# **Mendenhall Loop Road Capacity Improvement Project**

## **Project Advisory Group & Public Meeting Comment Summary**

*Prepared for Alaska DOT&PF by Kittelson & Associates Inc. and  
Sheinberg Associates*

**December 9, 2013**

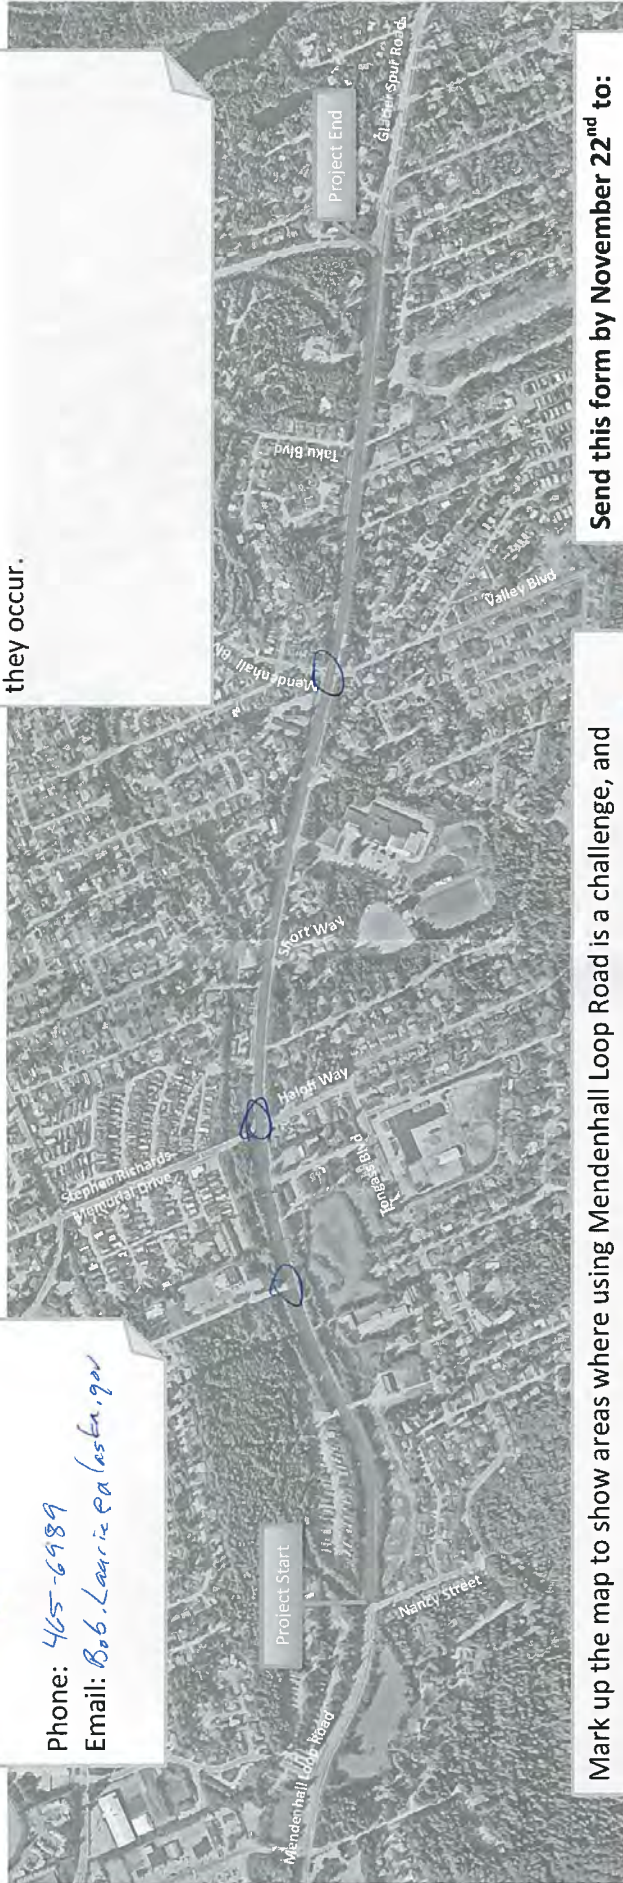
*Halseth Way - Consider making left turn lane left turn only (new left turn straight thru). But there is a right lane (or add lane). Turned right from Stephen Richards delays because of uncertainty over the left turn lane or left turn traffic conditions.*  
*Mendenhall Blvd Valley Blvd - yielding confusion*  
*10. dealing to 5-lane not needed. 3-lane sufficient. But intersection improvements at*  
*1) Stephen Richards + 2) Mendenhall Blvd Valley*  
*Cine on Park - need pedestrian crossing for transit stops. Transit pullouts/shelters*

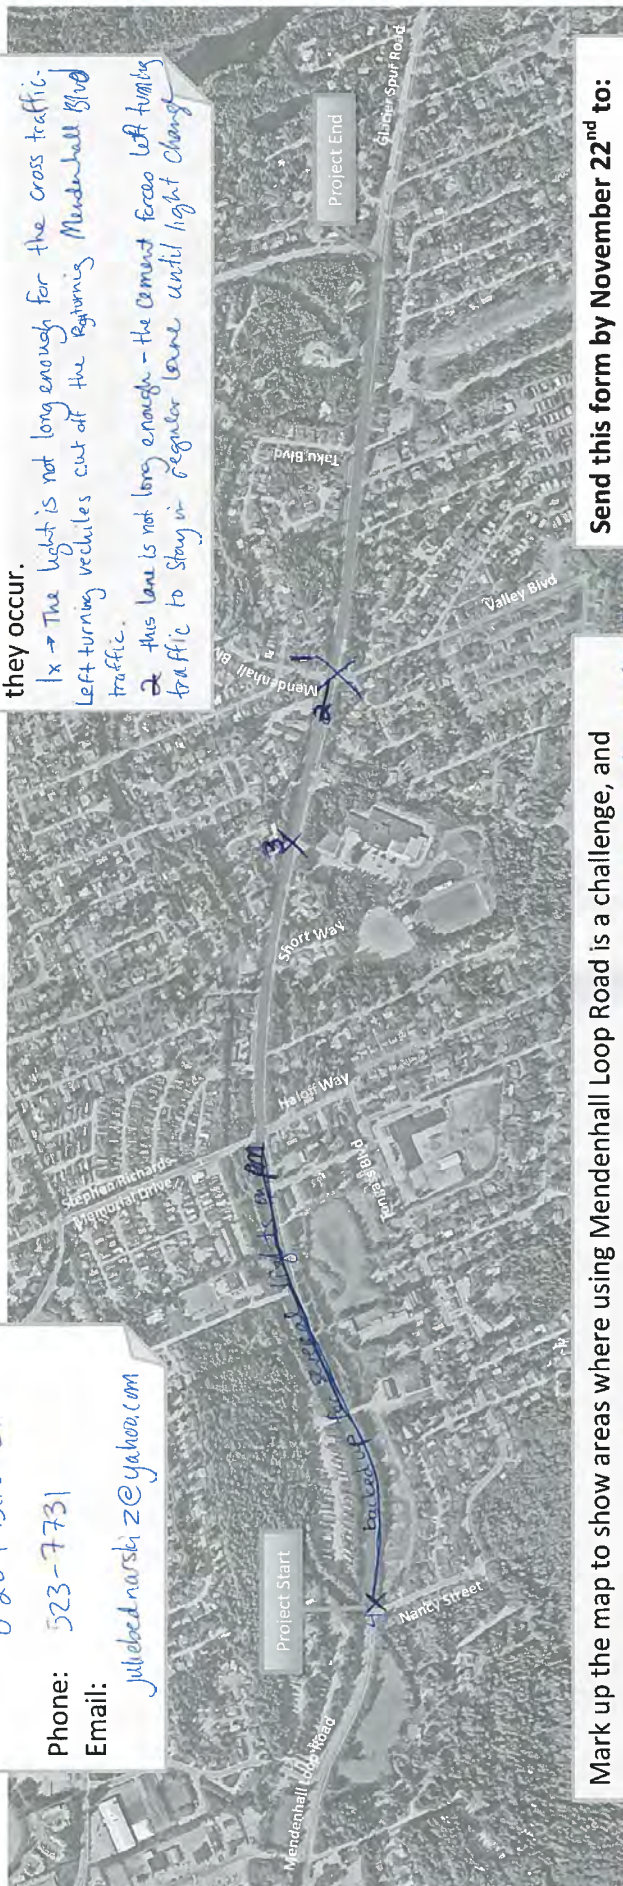
1x → The light is not long enough for the cross traffic. Left turning vehicles cut off the Righting Mendenhall Blvd traffic.  
2x this lane is not long enough - the cement fence left turning traffic to stay in regular lane until light change

Stephan Richards

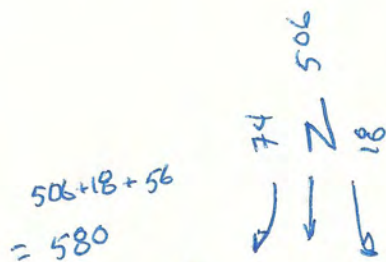
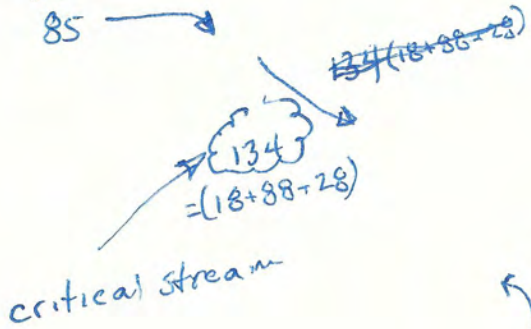
2 lanes enter from South

Note A: This is the important single feature of a roundabout over a traffic signal: people can cross in 2 stages with less delay to the vehicles. People cross one stream of traffic at a time, stopping traffic one direction at a time instead of the whole width of the street.

Stephen Richards Roundabout  
Traffic flows PM Peak

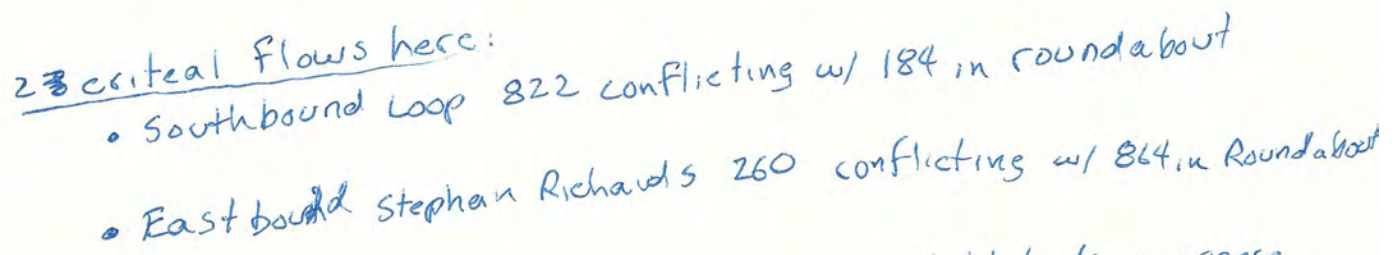
Critical streams of traffic  
Highest stream entering round about and the conflicting circulating flow in round about

→ Free right turn  $\Rightarrow$  2<sup>nd</sup> Lane from Stephen Richards

# N9 Traffic Light Alternative at Stephan Richards

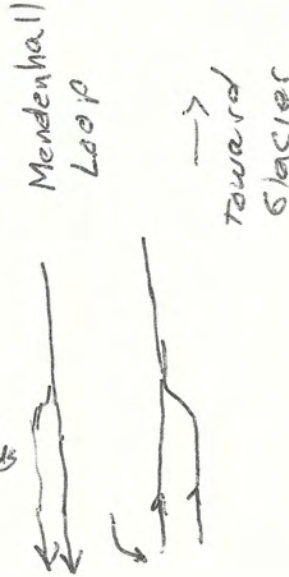
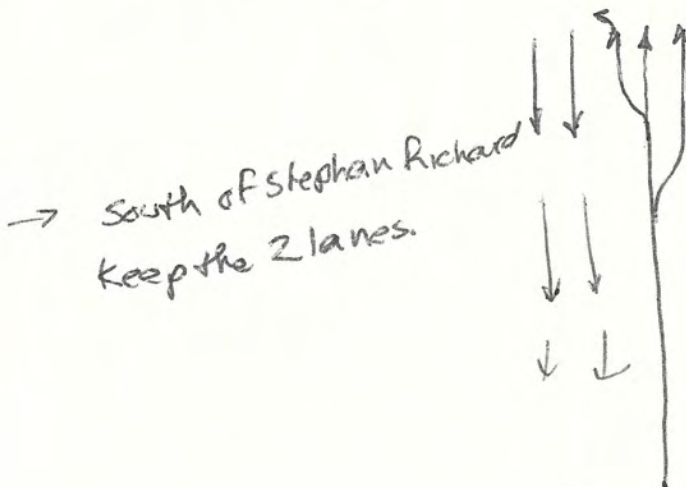
Widen from 1 lane  
to 2 south bound  
to increase through-  
put at Stephan Richards

Narrow back to  
1 lane N of  
Stephan Richard
